# Proposed Tg. Aru Eco Development, Kota Kinabalu, Sabah

Final Terms of Reference for Special Environmental  
Impact Assessment

Addendum 02 – Second Public Review: Response to Submissions

62800657-2-RPT-01-ADD-01 Rev. 01

Figure 1 – Proposed Development Plan dated 16-9-13

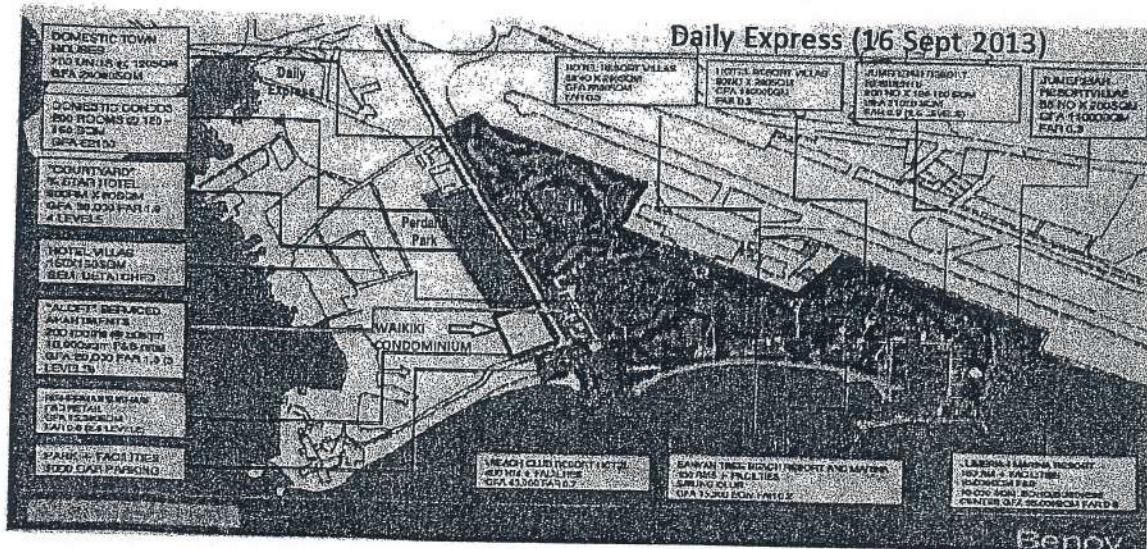
No	Item/Page	Comment	Action/Feedback by Proponent/ EIA Consultant
1	Development Plan	<u>Why does the Proponent NOT adhere to the Proposed Development Plan of 16/9/2013 and maintain the location of the ALOFT SERVICE APARTMENTS as per Figure 1? After all, it was the Proponent's own proposed development plan.</u>	There is no Development Plan at the time of writing. The Masterplan was updated based on further market studies among others. The revised TOR (revision 6) and the present Final TOR (revision 7) are based on the updated Masterplan dated June 2014.
2	DBKK zoning	The <u>land use designated</u> by the Government for the area where Sugar Bun and the Market Stalls sit is for <u>Public Recreation Reserve</u> . <u>Why alter the zoning from a Public Recreation Reserve to Medium/High density?</u>	N/A
3	Condominium Positioning	Proponent has claimed that the TAED development is a 700+ acre development. <u>Is there NO appropriate space (in the 700+ acre) to locate the ALOFT SERVICE APARTMENT other than IN FRONT of the Waikiki Condominium?</u>	To be assessed in the SEIA.

3. Comments/Questions to the Proponent from Waikiki Condominium Management Committee:
- a. Why does the Proponent NOT adhere to the Proposed Development Plan of 16/9/2013 and maintain the location of the ALOFT SERVICE APARTMENTS as per Figure 1? After all, it was the Proponent's own proposed development plan.
